### **AMENDMENTS TO THE DRAWINGS**

## REMARKS

In response to an Office Action mailed on July 5, 2006, Applicant respectfully requests that the above-listed amendments be entered and the Application be reconsidered. With entry of the above-listed Amendments, claims 1, 7, 8 and 16 are amended, and claims 22-23 are new. Thus, nineteen claims are presented for examination. Of these, claims 1, 8 and 16 are independent, and the remaining claims are dependent.

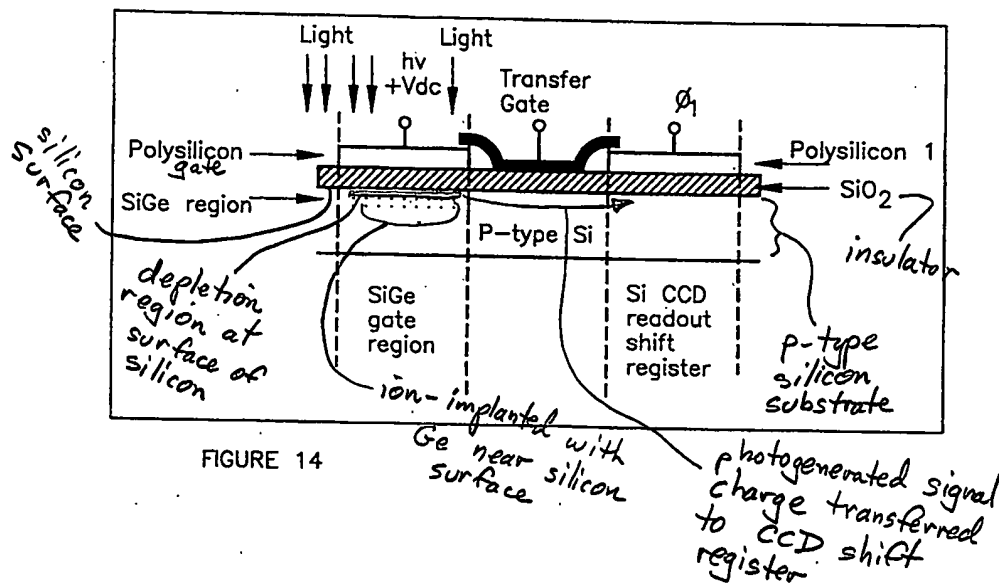
When positively biased, Selvakumar's polysilicon gate forms a depletion region at the surface of a silicon substrate (not in the polysilicon gate). (Col. 6, lines 48-50; emphasis added.) (See annotated Fig. 14, below.) This surface depletion region collects and stores photogenerated signal charge. (Col. 6, lines 51-53 and 57-60.) At the end of an integration time, the photogenerated signal charge is transferred to a normal silicon CCD shift register. (Col. 6, lines 60-62; Fig. 15.) The signal charge is not, however, conducted by the polysilicon gate. Instead, the signal charge is conducted through the p-type Si material under a "transfer gate" shown in Fig. 14. Indeed, the polysilicon gate is electrically insulated from the depletion region by a SiO<sub>2</sub> insulating layer. Thus, the polysilicon gate cannot conduct the photogenerated signal charge.

FIGURE 15

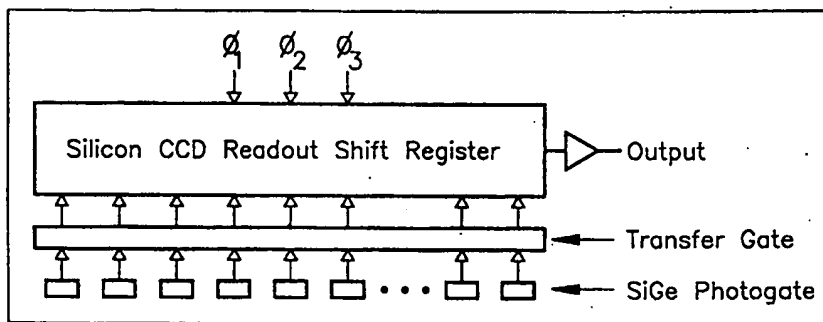
Although Selvakumar discloses a transfer gate (Fig. 14), the photogenerated signal charge is not conducted by the transfer gate. As shown in Figs. 15 and 17 (reproduced below), the transfer gate is common to a plurality of SiGe photogates. Thus, if the signal were conducted by the transfer gate, the signal charges from all the SiGe photogates would be short-circuited together. Instead, the transfer gate is insulated from the p-type Si material by the SiO<sub>2</sub> insulating layer. The transfer gate simply forms the gate of a MOSFET or another component that acts as a switch between the photogate and the CCD shift register.
